REVISIONS	
[1]	Redline Revision No. 1 May 12, 2005

MARYLAND DOT - STATE HIGHWAY ADMINISTRATION
Office of Traffic & Safety
TRAFFIC ENGINEERING DESIGN DIVISION
SIGNAL PLAN

MD 650 AT METZEROTT ROAD

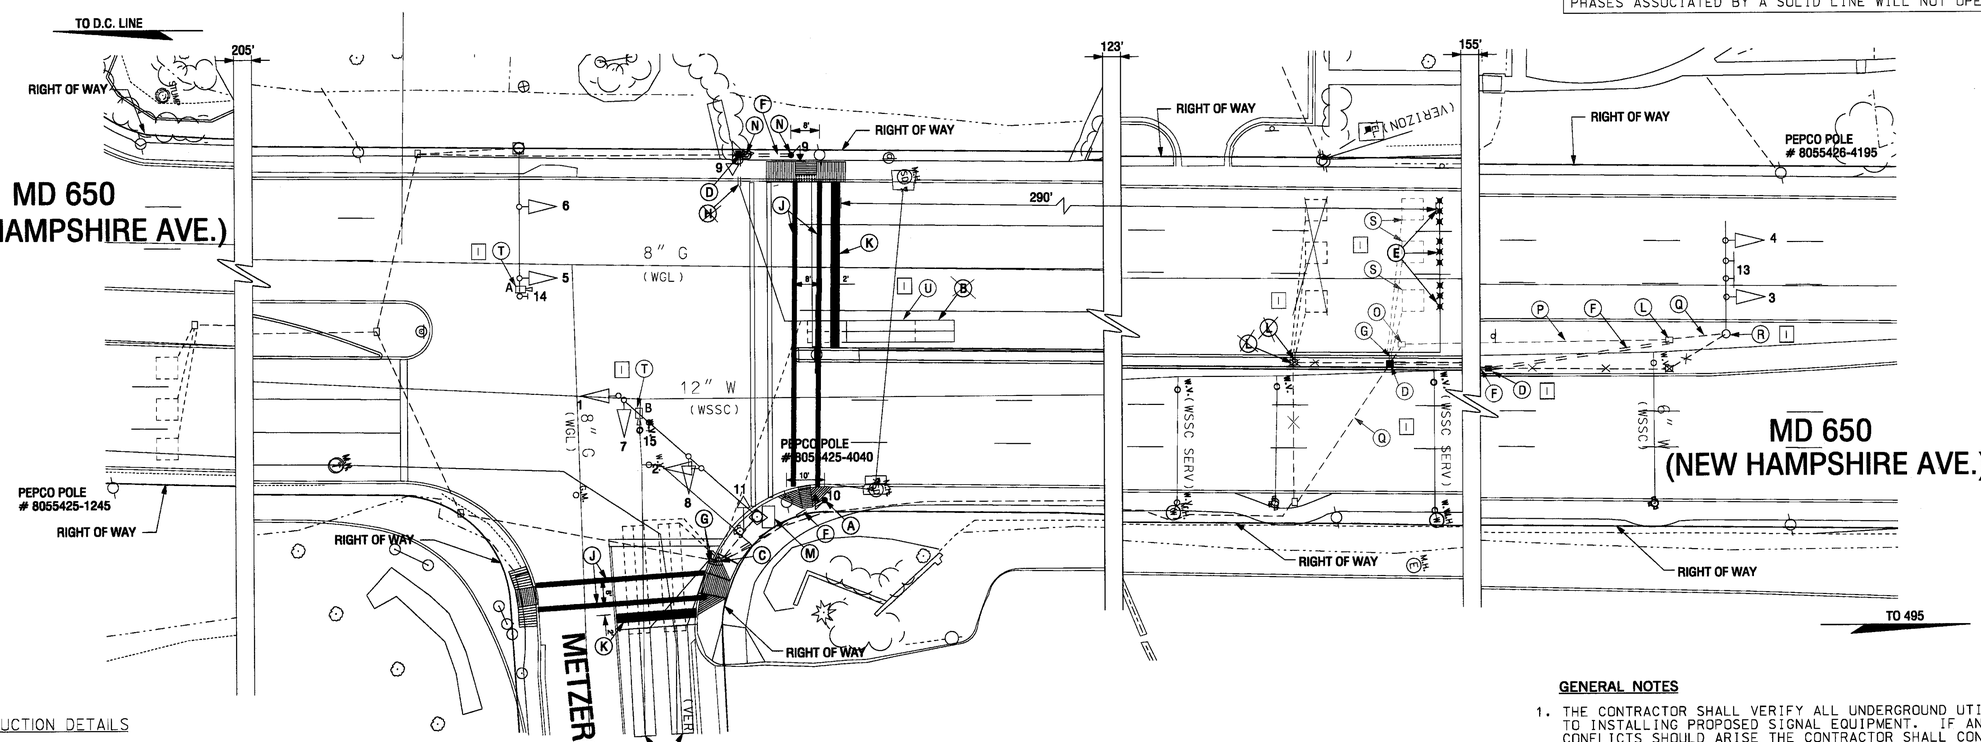
[1] VIDEO DETECTION CAMERA
A, B

[1] CONSTRUCTION DETAILS (CONT.)

S. Abandon Existing 6' x 6' Loop Detectors.

T. Install Video Detection Camera.

U. Video Detection Zone.

V. Install Handhole on Existing Conduit.
